**E&C REPORT – 20 AUGUST 2018 – CLAUSE C – ATTACHMENT B**

Our ref: MC17/4125

28 MAY 2018

### MINISTERIAL CONDITIONS FOR BRISBANE CITY COUNCIL'S PROPOSED FERNY GROVE UPPER KEDRON NEIGHBOURHOOD PLAN PURSUANT TO SECTION 117 OF THE SUSTAINABLE PLANNING ACT 2009

TITLE  
**CEDAR WOODS  
REGIONAL ECOSYSTEM**

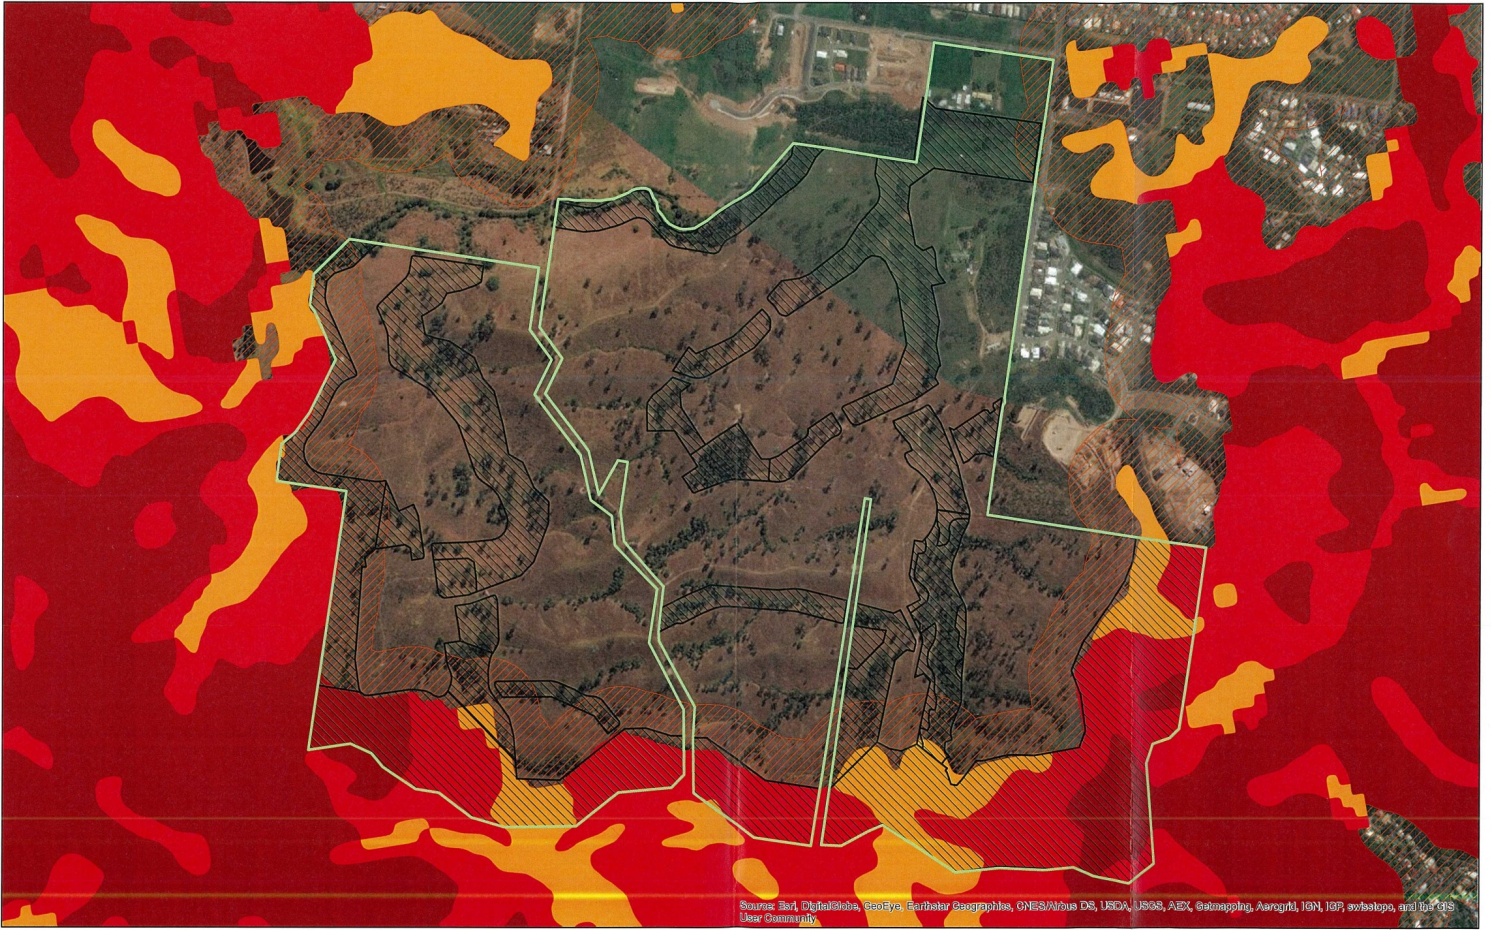
- (i) Include the enclosed regional ecosystems (REs)—*Regional ecosystem vegetation communities planned for the Cedar Creek south-precinct* to reflect the REs as shown on the attached "*Cedar Woods Regional Ecosystem*" (refer **Enclosure 2**) and amend **Table 8.2.5.3.A, A021.2 (a) of the Performance outcomes and acceptable solutions** of the Bushfire Overlay code to include the reference *Regional ecosystem vegetation communities* (as per **Enclosure 2**).
- (ii) Amend *Map 5—OM-002.3* to show the future bushfire risk for the Ferny Grove-Upper Kedron Area (as per **Enclosure 3**).
